UNITED STATES
NUCLEAR REGULATORY COMMISSION

MEMORANDUM FOR: Docket No. 40-1162

FROM: Raymond O. Gonzales, Project Manager

SUBJECT: PROPOSED AMENDMENT TO SOURCE MATERIAL LICENSE SUA-56 TO
REVISE THE APPROVED DISPOSAL AREA RECLAMATION AND CLOSURE
PLAN FOR WESTERN NUCLEAR, INC.'S SPLIT ROCK MILL NEAR
JEFFREY CITY, WYOMING

(MODIFIED FROM WNI SUBMITTALS)

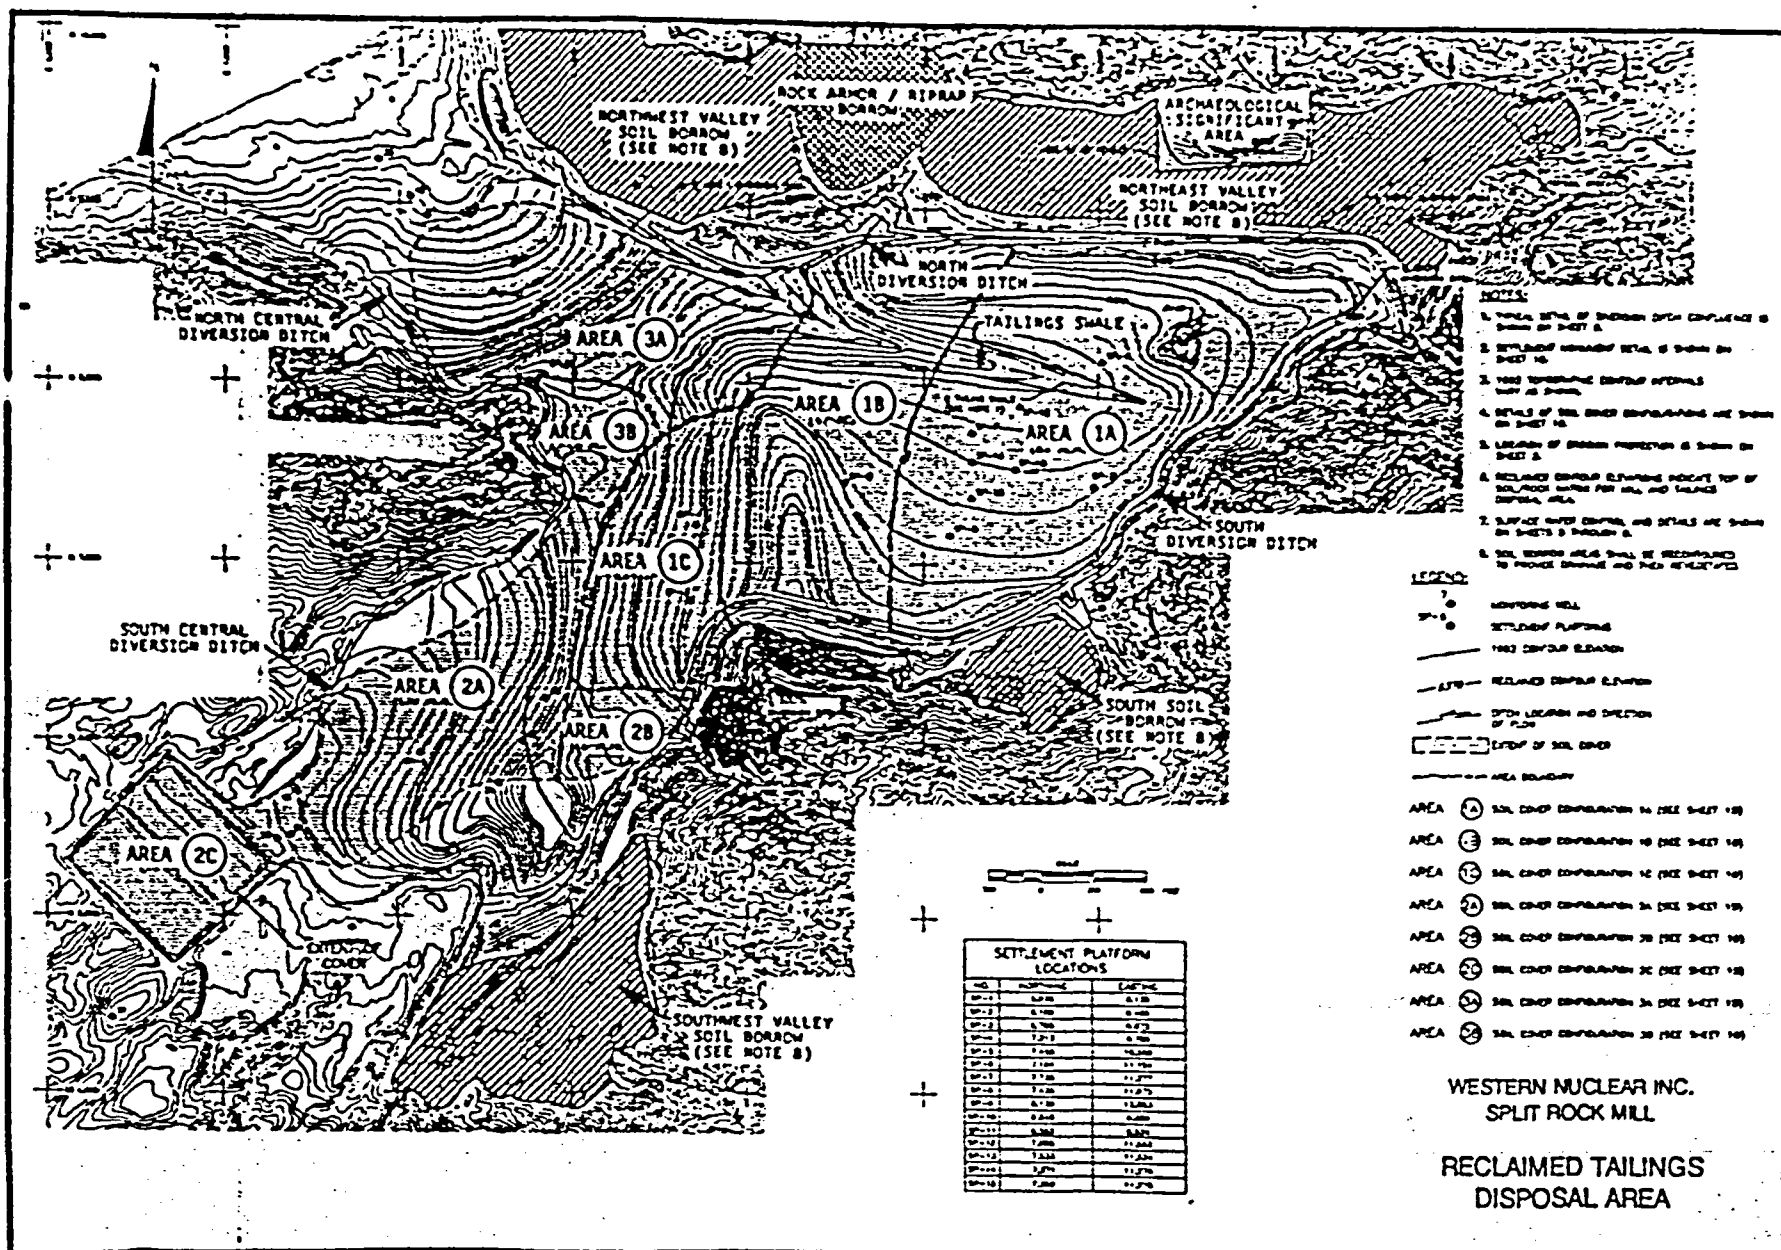
As shown on the attached figure, and on Figure 5, Drawing No. 91-225-E54, (Addendum A to Revision 5), the surface of the tailings area will be regraded to drain into a central swale on top of the pile. To protect against erosion, the pile top will be covered with a layer of compacted rock and soil to form a soil/rock matrix, and the swale will be covered with riprap (rock). The heights of the two tailings embankments will be reduced by as much as 30 feet and the slopes, which are about 4H:1V, will be regraded to much flatter configurations of about 10H:1V and 20H:1V. Four rock-lined (riprapped) ditches; the North Diversion Ditch, the South Diversion Ditch, the North Central Diversion Ditch, and the South Central Diversion Ditch, will divert

| For design purposes, the reclamation area was divided into seven areas. As shown on the attached figure, Areas 1A and 1B represent the east and west new

tailings areas, respectively, Areas 1C and 2B represent the north and south old tailings areas, respectively, Area 2A represents the alternate tailings area, Area 2C represents the winter storage ponds, and Areas 3A and 3B represent the mill area with and without tailings, respectively. The proposed design of the radon attenuation barrier for each of the seven areas is shown on Figure 10, Drawing No. 91-225-E59 (Addendum A to Revision 5).

The radon attenuation barrier is comprised of an imported clay layer (Cody Shale) and a borrow soil layer placed over the clay. The onsite soil borrow areas are shown on the attached figure and on Figure 3, Drawing No. 91-225-E52 (Addendum A to Revision 5). To obtain representative parameters, 132 samples were taken from the 8 borings and 14 test pits shown on Figure 1 (Addendum A to Revision 5), and composited into 3 representative samples. Gradation tests

Soil/Rock Matrix - The soil/rock matrix shall consist of sized angular granite and soil obtained from the specified onsite borrow sources shown on the attached figure and on Figure 3, Drawing No. 91-225-E52 (Addendum A to Revision 5); soil obtained during excavation of the ditches; or alternate sources approved by the licensee. The soil must be acceptable as specified above. The rock shall meet the scoring criteria discussed in Appendix D of the Staff Technical Position on Erosion Protection (NRC, 1990) (Section 5.2.1, Addendum A to Revision 5). The rock material shall be angular, resistant to abrasion and weathering, and shall be free from cracks, seams, and other defects that would tend to increase weathering by water and frost action. The rock shall be well graded and sized as specified in Table 2C of Addendum A to Revision 5.
